U.S. Application Serial No. 10/696,791
Attorney Docket: 46107-0087
Reply to Office Action of April 4, 2005

Amendments To The Drawings:

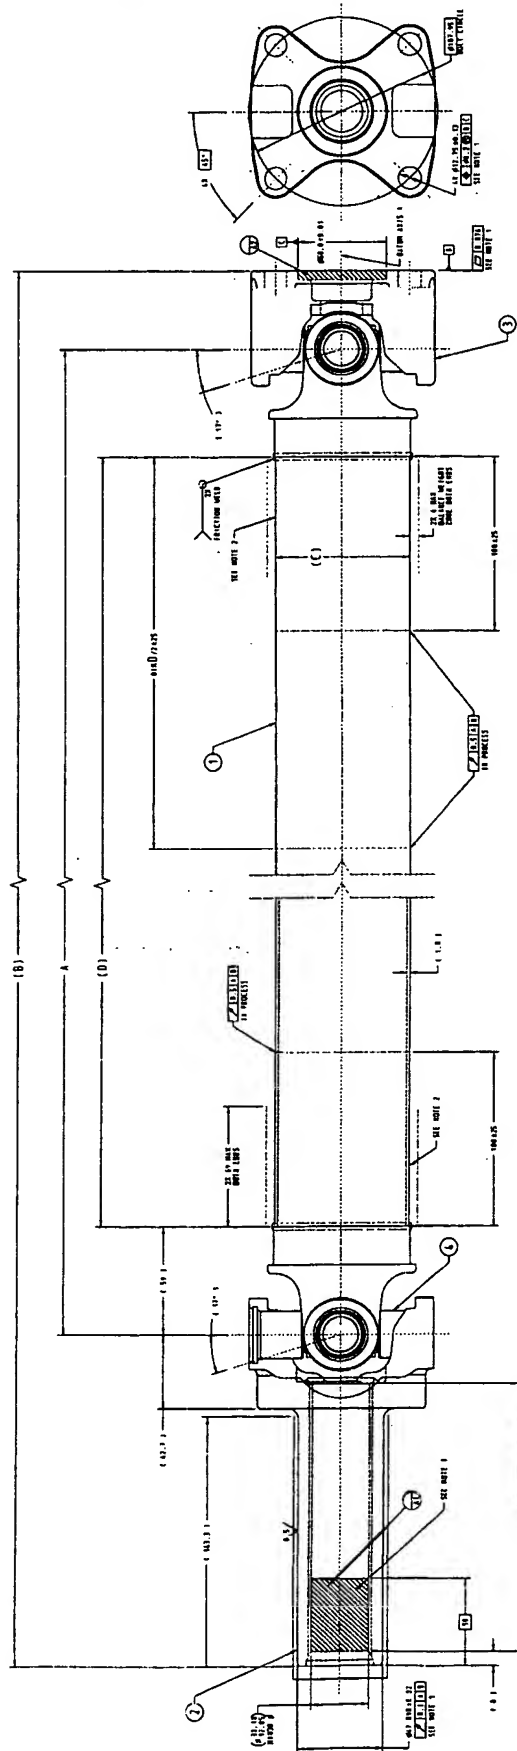
In response to the Examiner's objection to the drawings for failing to show stake grooves, and the scale of the drawings being too small to show the details described in paragraph [0037] and recited in Claim 4, Applicants have submitted a replacement sheet for FIG. 3A. Applicants respectfully submit that the stake grooves are clearly shown in sufficient scale and now are labeled 46 in FIG. 3A. Furthermore, Applicants respectfully submit that the drawings previously filed with the application clearly identify the stake grooves in FIGS. 1, 3B, 5 and 6 with numeral 46 and clearly show the stake grooves in sufficient scale in FIGS. 1, 3A, 3B, 5 and 6.

The attached substitute drawing sheet for FIG. 3A has been redrafted to enlarge the figure to better show the stake grooves and to add reference numeral 46, but has not been changed in any substantive manner.
